SUBJECT: SEP SAFETY TOPIC II-4.F, SETTLEMENT OF FOUNDATIONS AND
BURIED EQUIPMENT - LACROSSE BOILING WATER REACTOR

SYSTEMATIC EVALUATION PROGRAM TOPIC ASSESSMENT

TOPIC: II-4.F - SETTLEMENT OF STRUCTURES AND BURIED EQUIPMENT

PLANT NAME: LA CROSSE BOILING WATER REACTOR PLANT (LACBWR)

Figure 1 LACBWR Site Location Plan

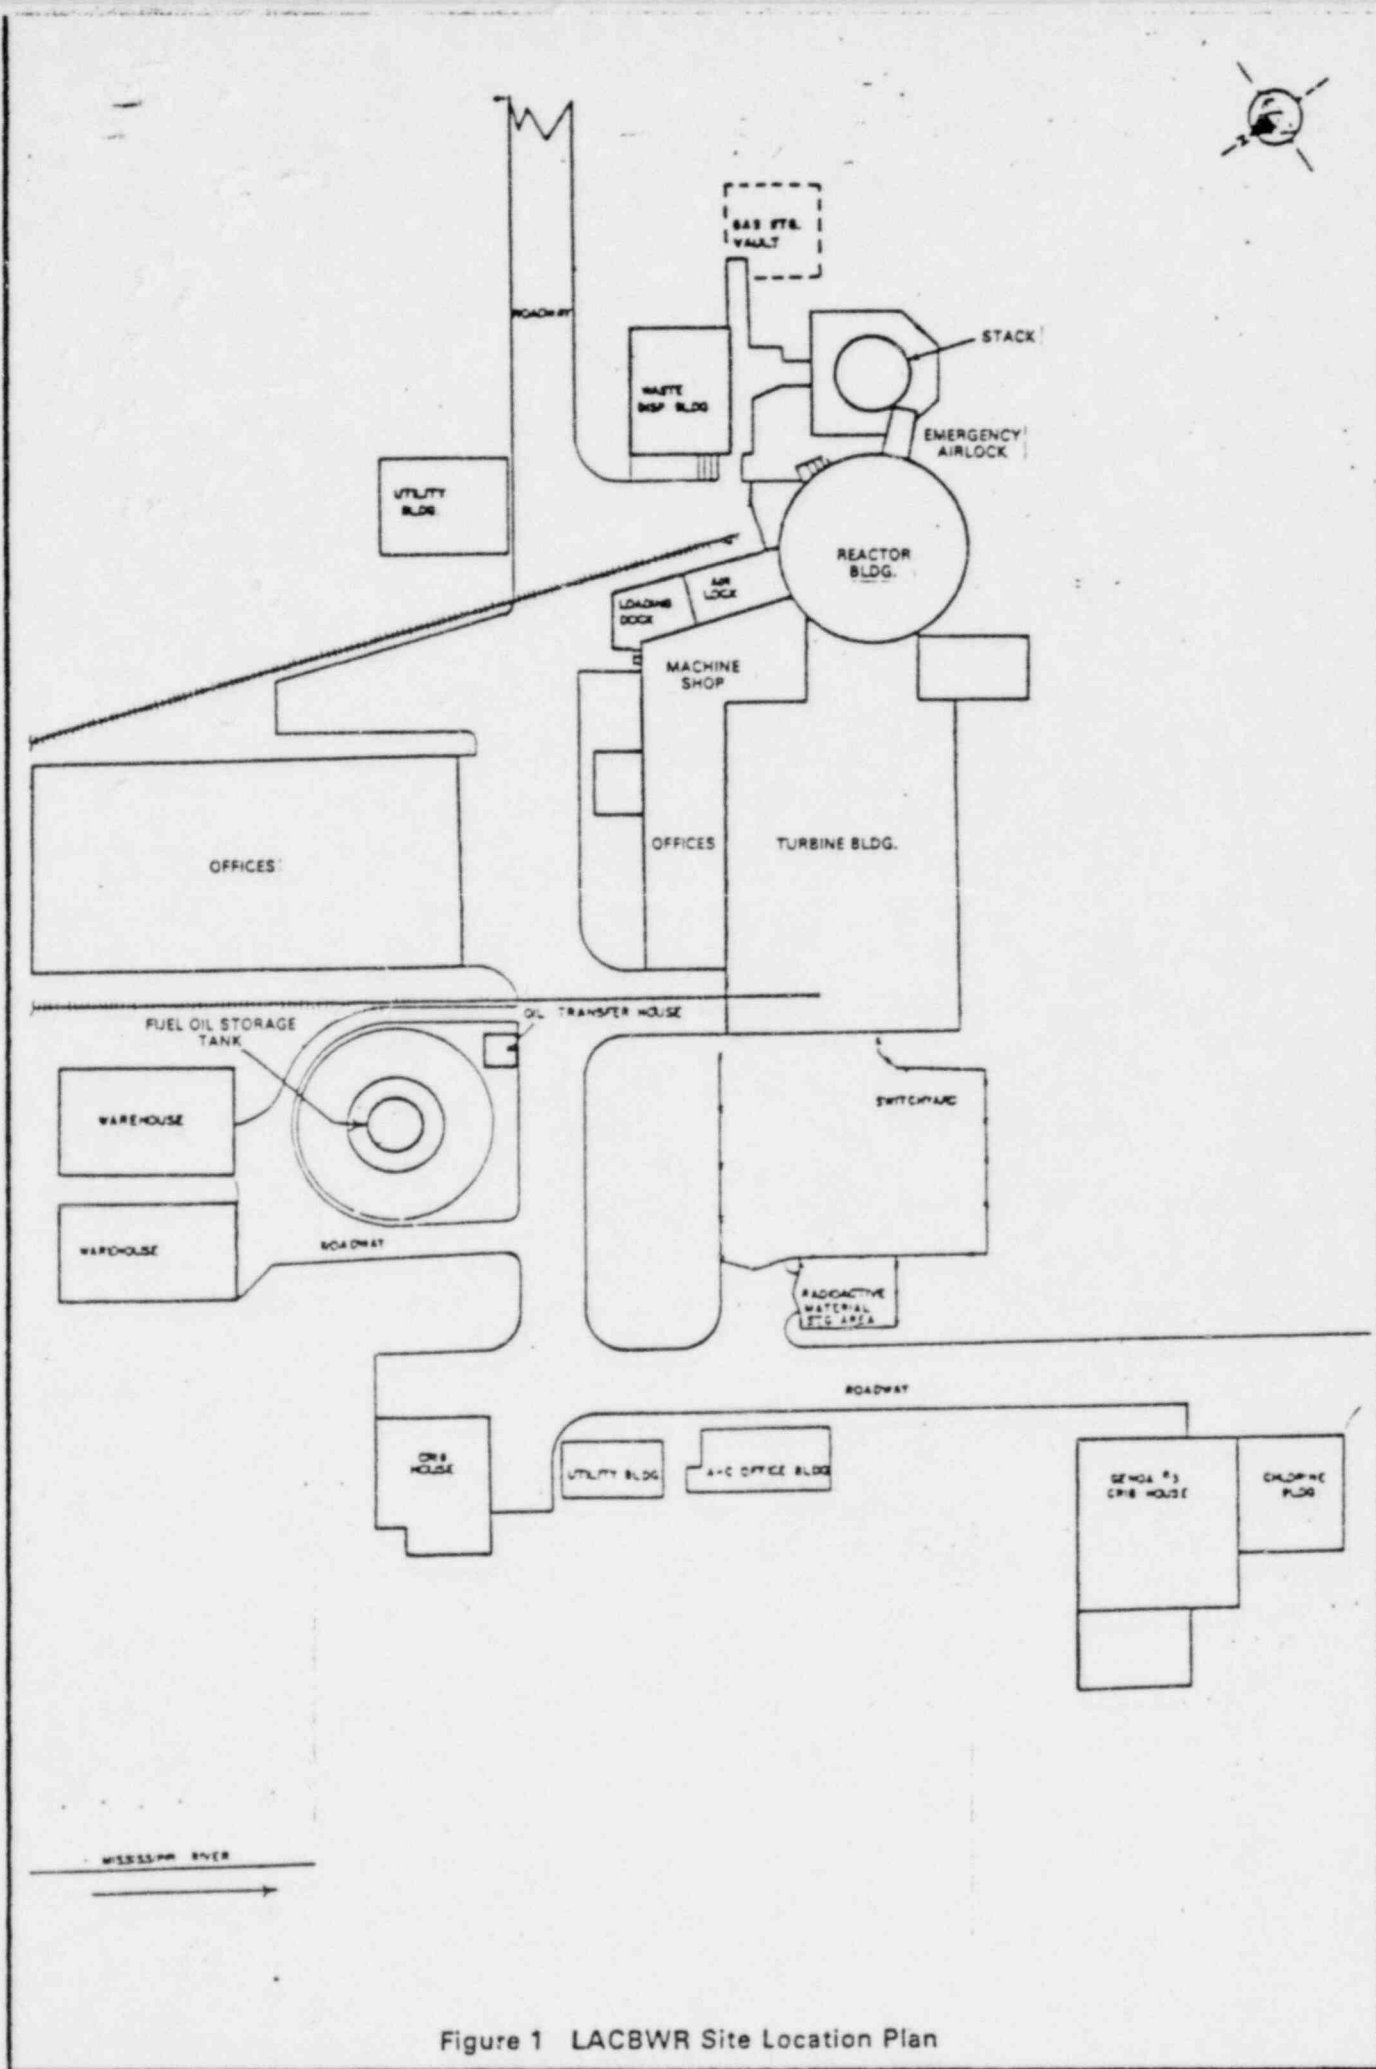
The main plant facilities include a reactor containment building, turbine building, 350 ft high stack, gas vault structure, diesel generator building, waste disposal building, crib house and a circulating water system. All of the facilities except the crib house and the circulating water system are supported on piles. Figure 1 presents a site location plan for the LACBWR plant facilities.

Figure 2 Soil Test Borings

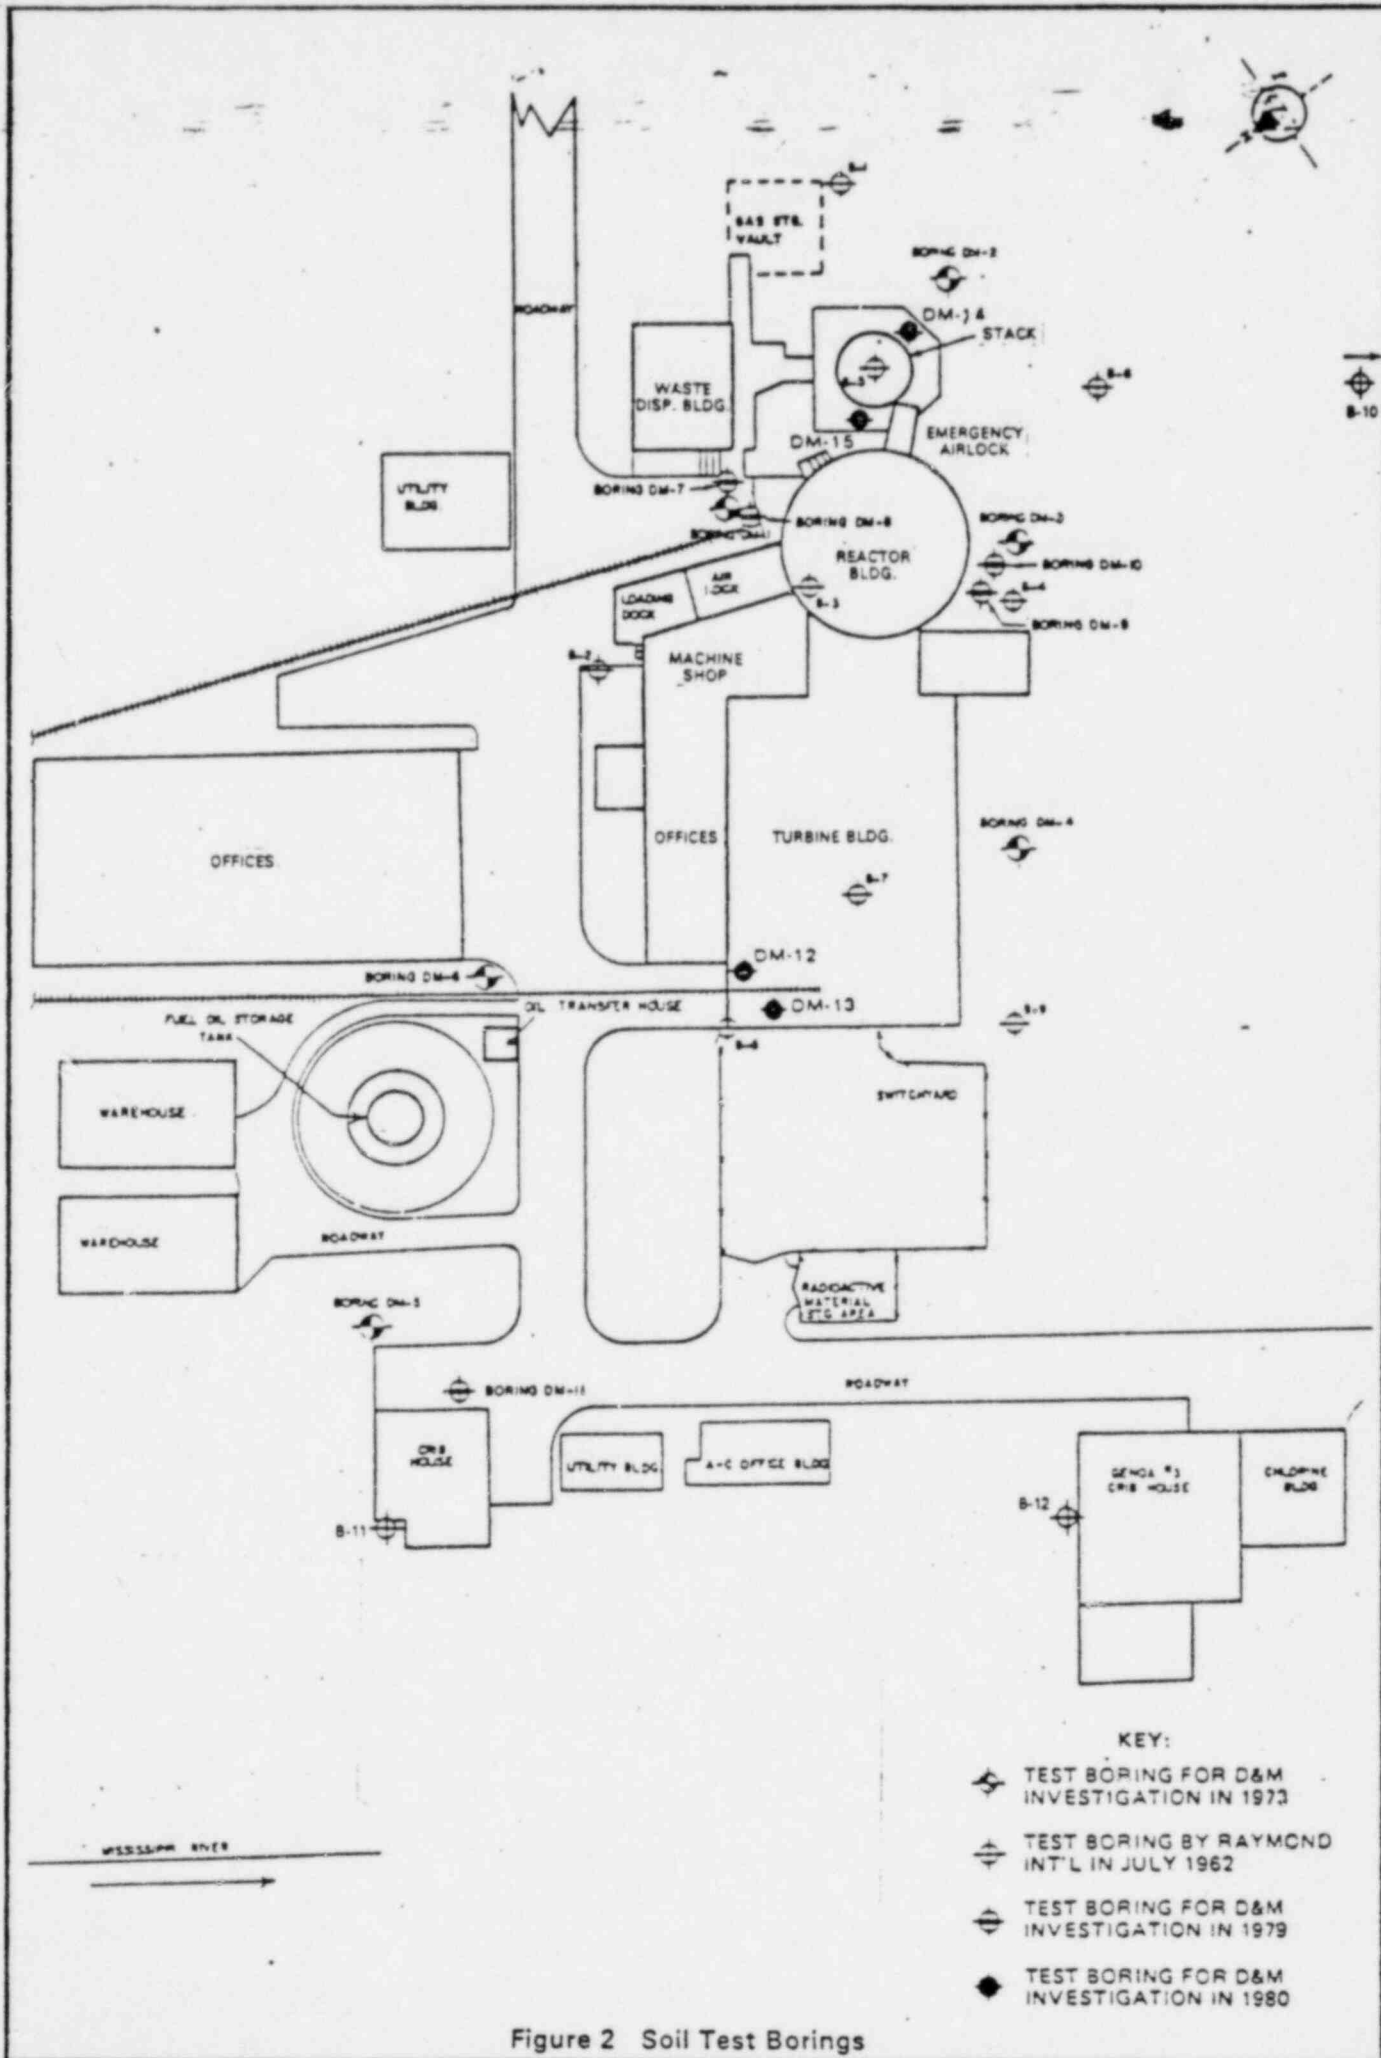
The initial soil investigations at the LaCrosse site were conducted in 1962. Between 1962 and 1980 soil test borings were made at 36 locations in the site vicinity. Of this number, five were associated with subsurface investigations in the power station area, four were associated with the switchyard area, and one was drilled to locate an offsite borrow area for construction fill materials. The remaining 23 were associated with subsurface investigations in the main plant facility area (see Fig. 2). The licensee has presented boring logs depicting the soil conditions encountered in these investigations (Refs. 1, 2, 3, & 4). Field investigation effort included standard penetration tests (SPT) and split-barrel sampling in accordance with ASTM D-1586-67 procedures. Relatively undisturbed samples were also obtained at several locations in thin walled tubes using an Osterberg piston sampler. Laboratory testing of soil samples was accomplished to determine index properties and to establish soil strength parameters. Testing included specific gravity determinations in accordance with ASTM D-854-58, particle size analysis testing in accordance with ASTM D-422-63, relative density determinations in accordance with ASTM D-2049-69 and cyclic triaxial testing in accordance with the procedures of NUREG-0031 (Ref. 5). A generalization of the site soil profile developed from the geotechnical investigations performed at the site is presented in Figure 3.
